ACCESS REPORT
28 LOCKWOOD AVE
BELROSE NSW 2085

Multi-storey mixed-use building over a basement

Report: **A242024-R1.2a**
Date: **11 December 2024**
Prepared for: **Platinum Property Advisors No. 1 Pty Ltd**

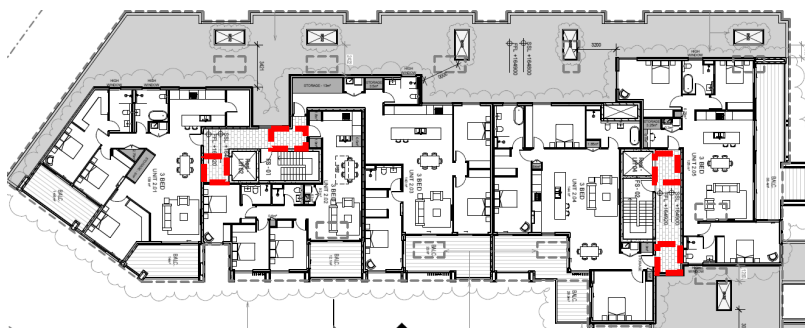
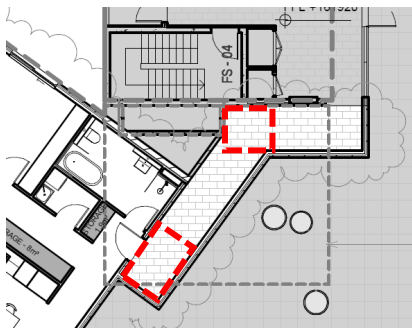
Plans need to show corridors that are more than 2 m are provided with 180 turning space of 2070 mm x 1540 mm throughout class 2 common areas. 90 degree turning space of 1500 mm x 1500 mm also needs to be shown.
